TECHNICAL BULLETIN

Rain Sensing Wipers –
Remove Diode/Install 5 Amp Fuse –
Service Action S164

MODEL 2005 MY
S-TYPE
VIN N13089-N25488

ILLUSTRATION 1

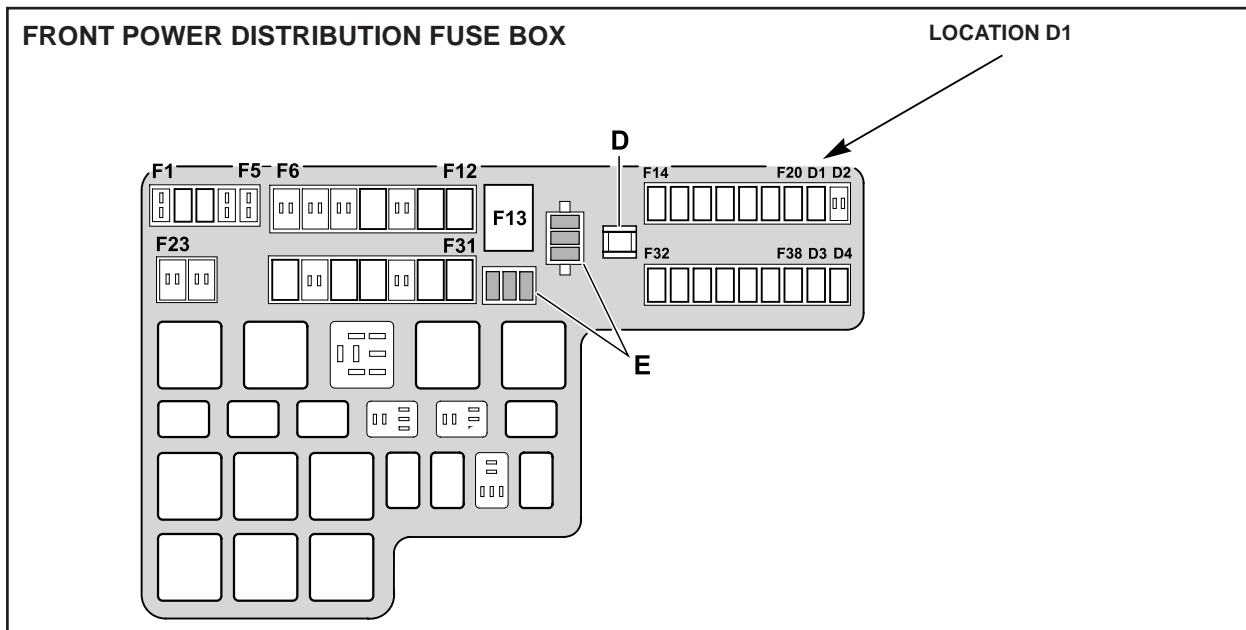
A concern has been identified on a number of 2005 S-TYPE vehicles within the above VIN range. Vehicles equipped with rain sensing wiper control may mistakenly have a diode installed in location D1 of the front power distribution fuse box (located in the engine compartment) instead of the 5 amp fuse that should be in this location.

If a diode is present in location D1, Illustration 1, replace it with a 5 amp fuse. If a 5 amp fuse is present, no further action is required.
